RANGELINE BUSINESS PARK SUBDIVISION, **REVISED UNIT 1**

APPLICATION NUMBER 16 DATE February 4, 2010

APPLICANT Rangeline Business Park Subdivision, Revised, Unit One

DETAIL SITE PLAN

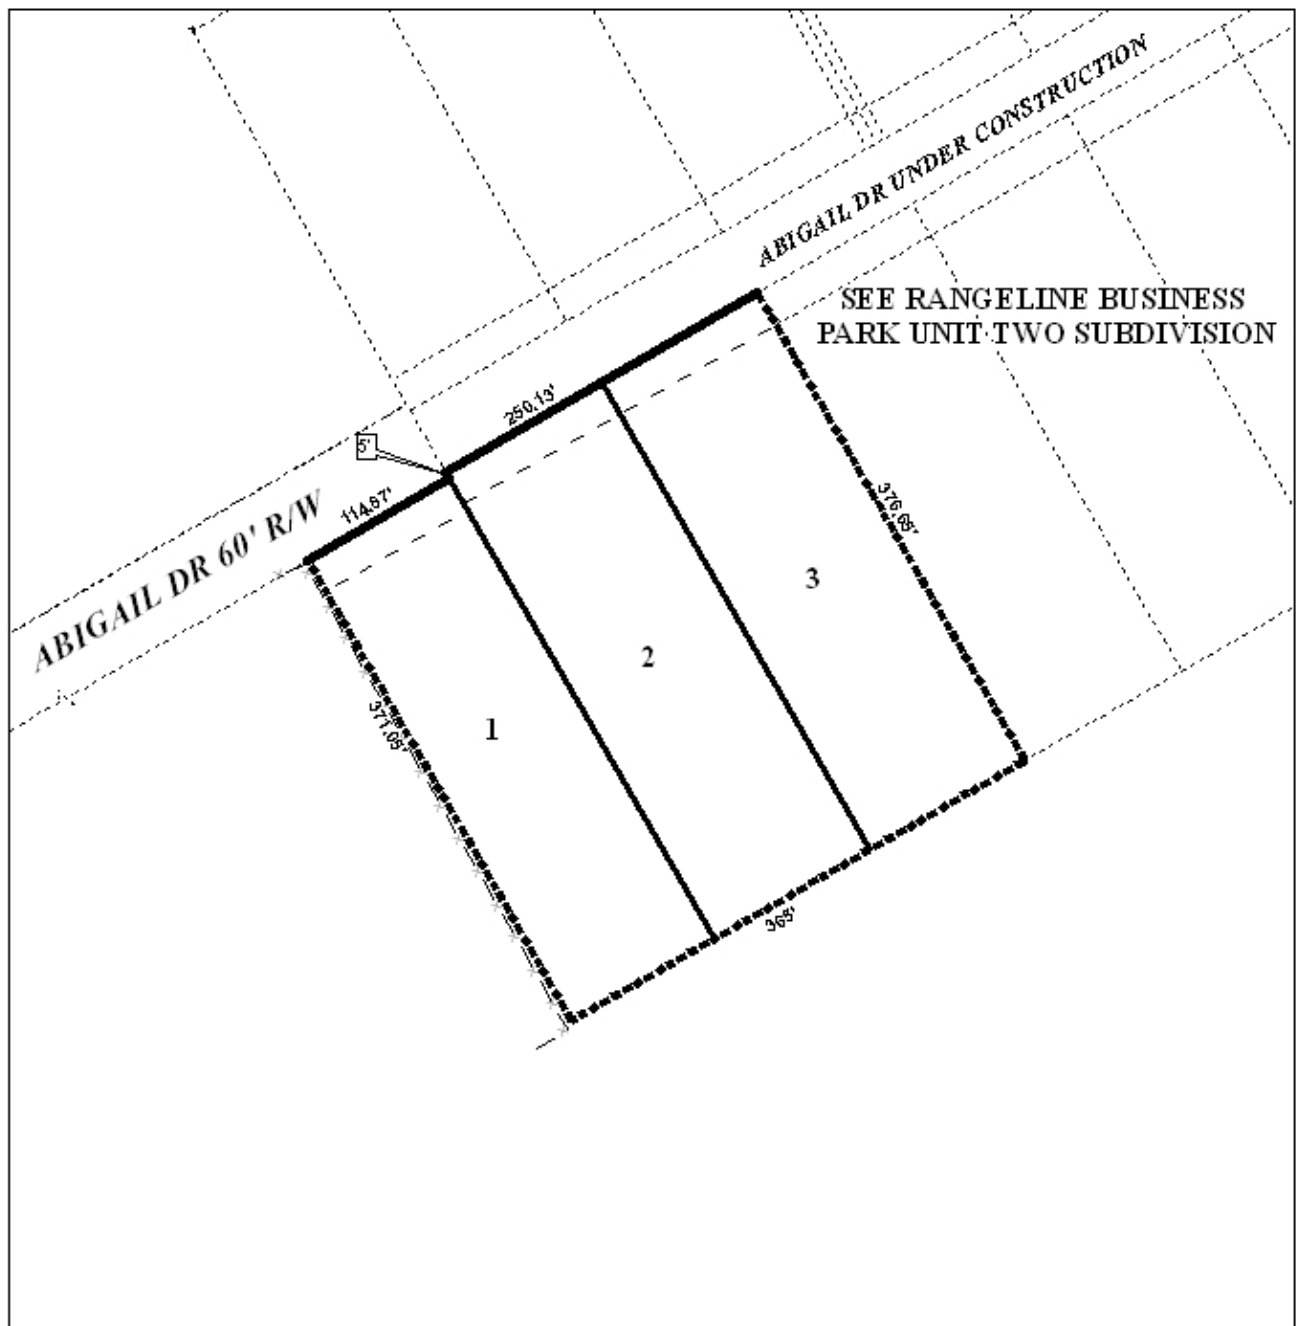
The proposed lots, as depicted, meet the minimum size and frontage requirements as regulated by the Subdivision Regulations. The areas of the lots are not depicted on the plat, and should be shown on the Final Plat in square feet, or a table provided on the Final Plat with the same information, if approved.

The site fronts Abigail Drive, a minor street provided with curb and gutter. The street is depicted with an adequate right-of-way of 50 feet. As such, no further dedication should be required. Abigail Drive is depicted as being "under construction." In the original approval, the Commission put a condition on the plat that no certificate of occupancy would be issued to any building constructed in Unit 1 until Abigail Drive was constructed and accepted for maintenance by Mobile County. Since the original approval, the area has been annexed into the City of Mobile. As such, Abigail Drive would need to be constructed to City of Mobile standards and accepted for maintenance by the City. Further, the proposed Lot 2 and Lot 3 both have the entirety of their frontage on the unfinished portion of Abigail Drive. Because of this, Abigail Drive would need to be completed and dedicated prior to signing of the final plat.

temporary turnaround is provided by the applicant, the entirety of Abigail Drive should be completed to City Standards and accepted for maintenance prior to signing of the final plat. Once Abigail Drive is completed, each lot should be limited to one curb cut each, with the size, design, and exact location of all curb cuts to be approved by Traffic Engineering and conform to AASHTO standards.

The 25-foot minimum building setback line is depicted on the preliminary plat, and this should be retained on the Final Plat, if approved.

- 1) completion of Abigail Drive to City Standards, and acceptance of the same, either in its entirety, or with a temporary turnaround prior to signing of the Final Plat;

- 2) depiction of the lot area sizes, in square feet, or provision of a table on the Final Plat with the same information;
- 3) retention of the 25-foot minimum building setback line on the Final Plat;

- 4) placement of a note on the Final plat stating that each lot is limited to one curb cut to Abigail Drive, with the size, design, and exact location of all curb cuts to be approved by Traffic Engineering and conform to AASHTO standards;
